ADDENDUM 01

DATE 04.08.25
PROJECT NO. 2322
PROJECT LEWISTON 1, 2 ELEVATOR ADDITION AND HVAC REMODEL
FROM STUDIO 333 ARCHITECTS

This Addendum consists of 2 page(s) and the attached agreement "Agreement Between Owner and Contractor For A Fixed Sum", Specification 08 0601 - Hardware Group and Keying Schedules, and Drawing Sheet(s) D1.2 - 2nd Level Demolition Plan, A1.2 - 2nd Level Annotated Plan, A9.1 - Door Schedule, Window Elevations & Opening Details

D1.2

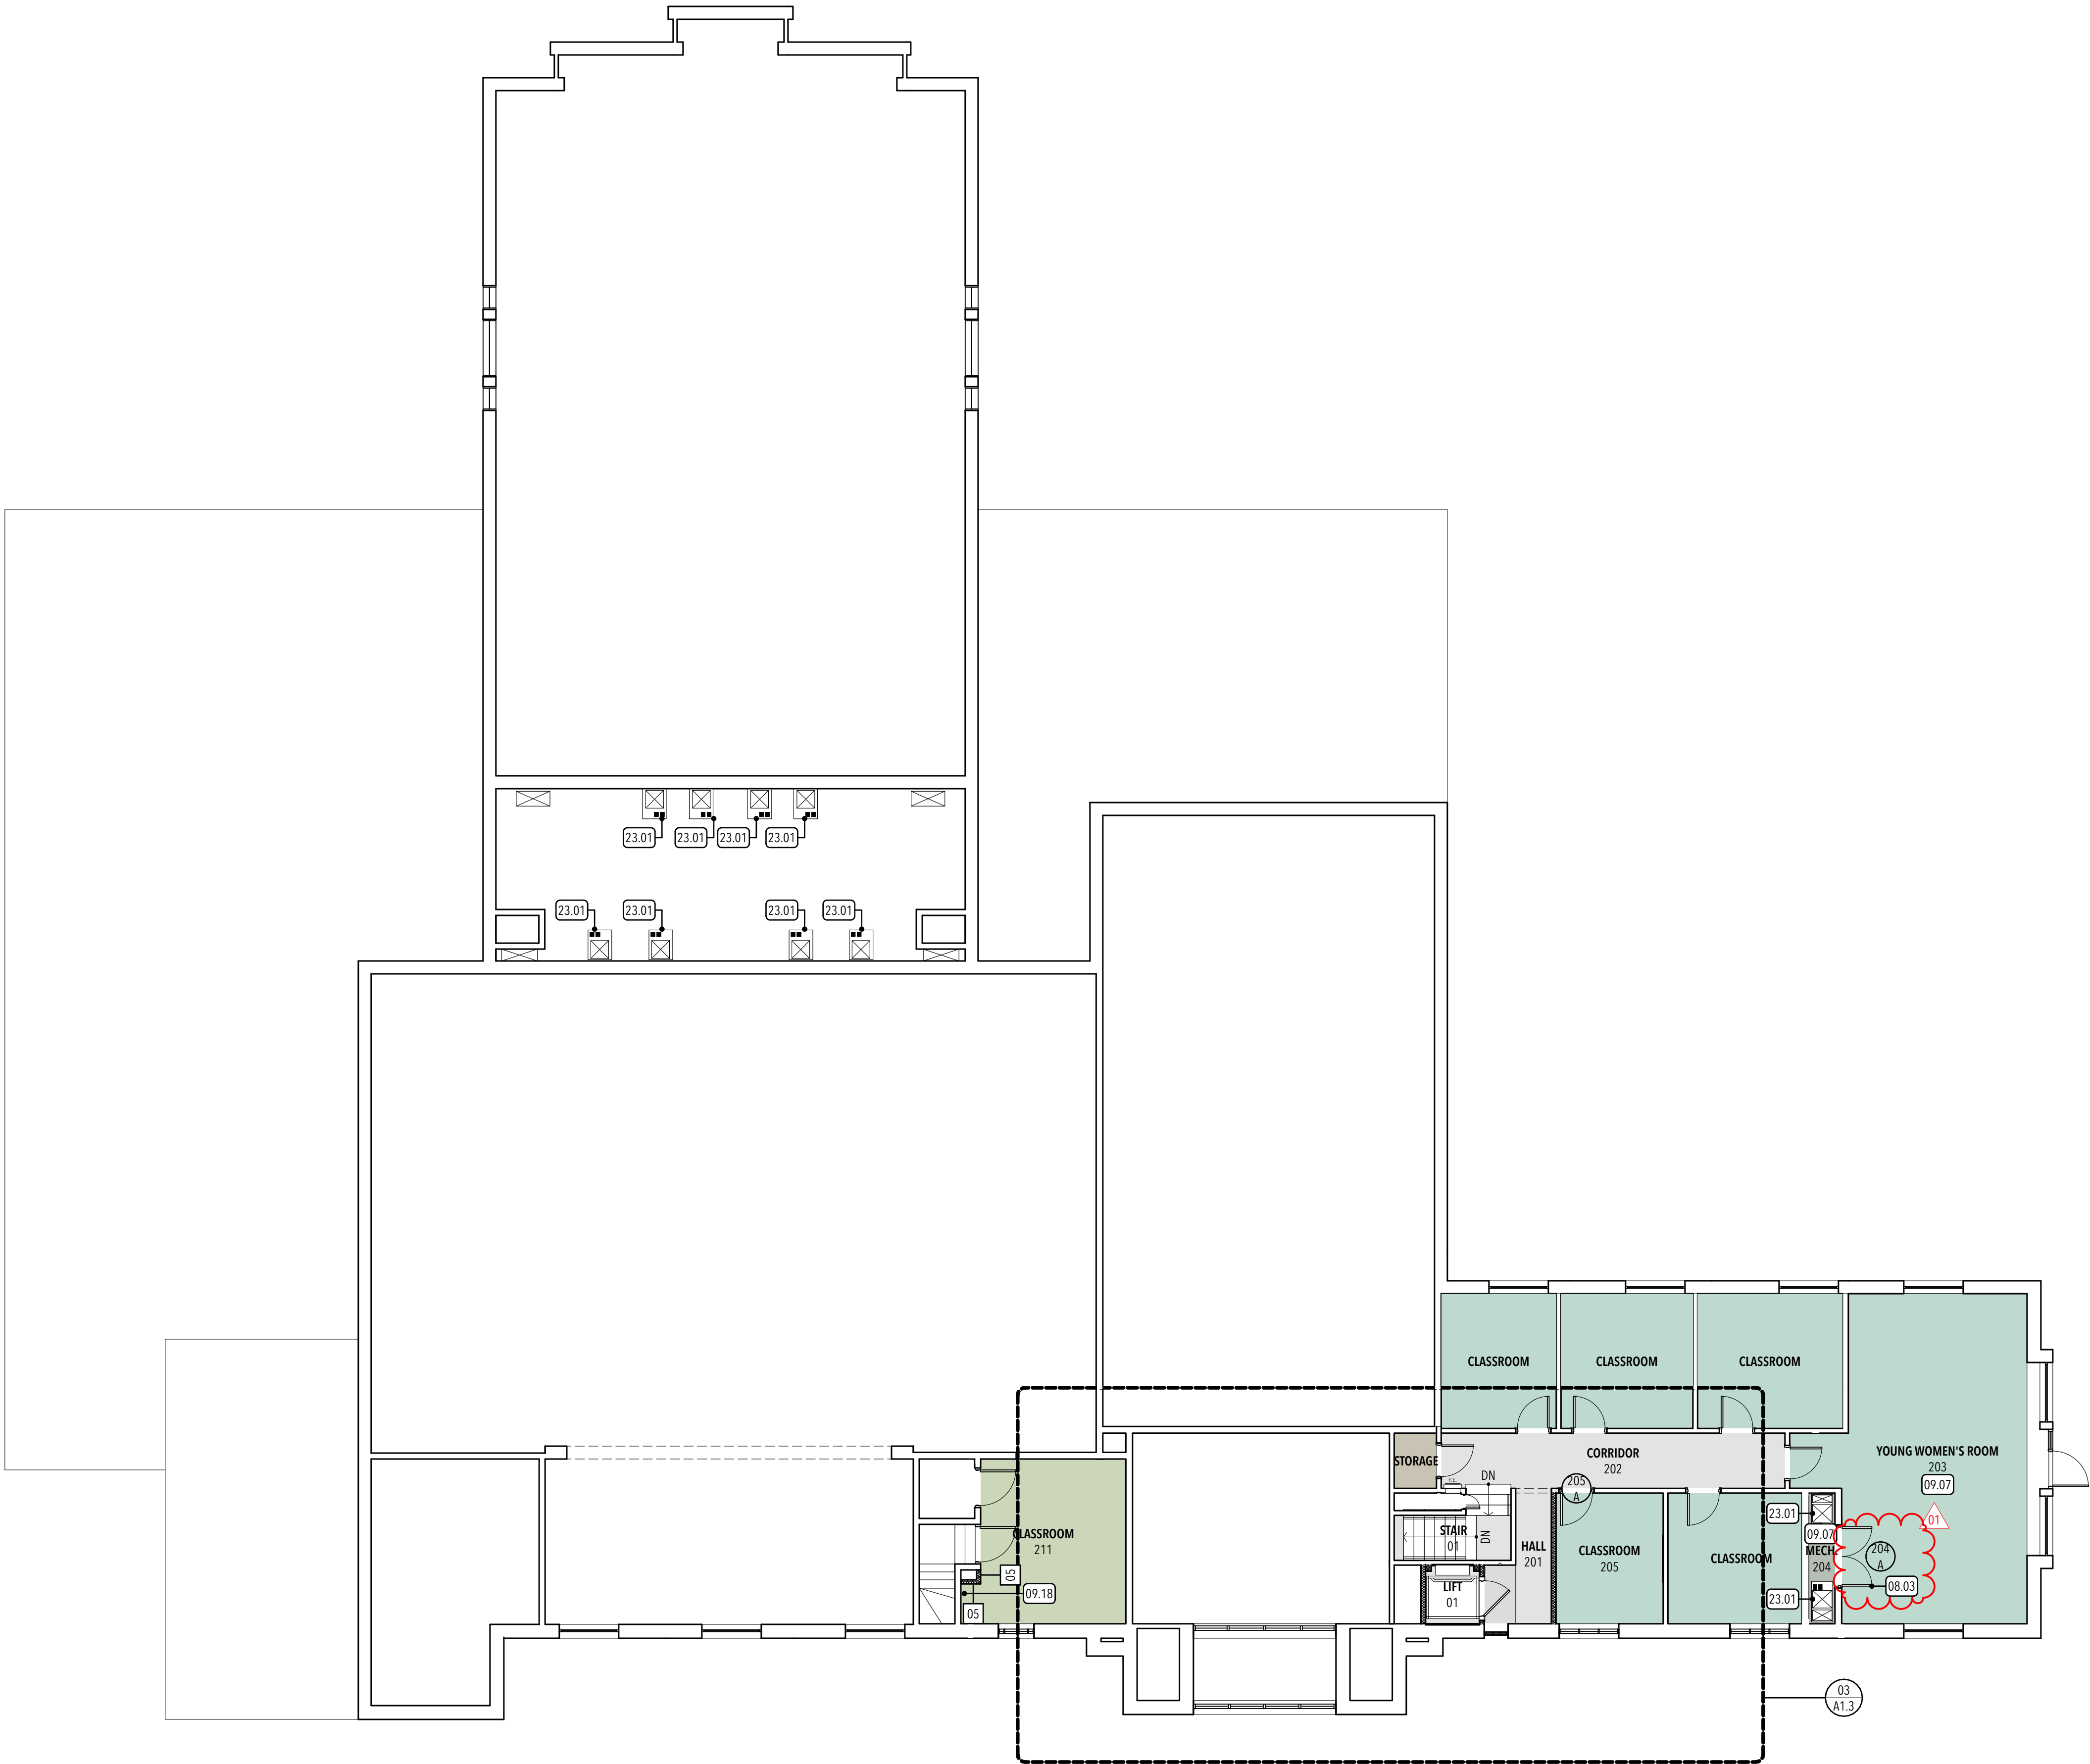
- C. Changes to drawings:
 - 1. All Drawing Sheets:
 - a. The direction of the North Arrow has been corrected.
 - 2. Sheet D1.2 - 2nd Level Demolition Plan:

- a. Add note to remove the door leaves at Mech. 204.
 - 3. Sheet A1.2 - 2nd Level Annotated Plan:
 - a. Add note to install new solid core wood door leaves at existing door frame 204/A.

A9.1

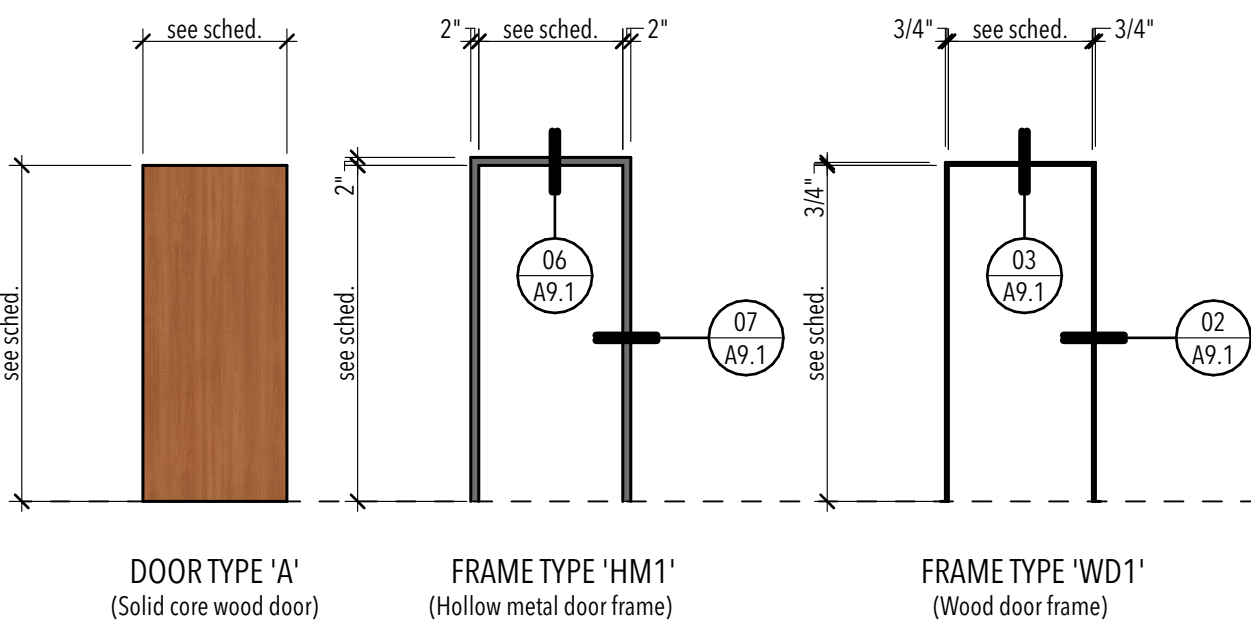
- 4. Sheet A9.1 - Door Schedule, Window Elevations & Opening Details:
 - a. Add door 204/A to the Door Schedule.
 - b. Add hardware group listing to the Door Schedule.
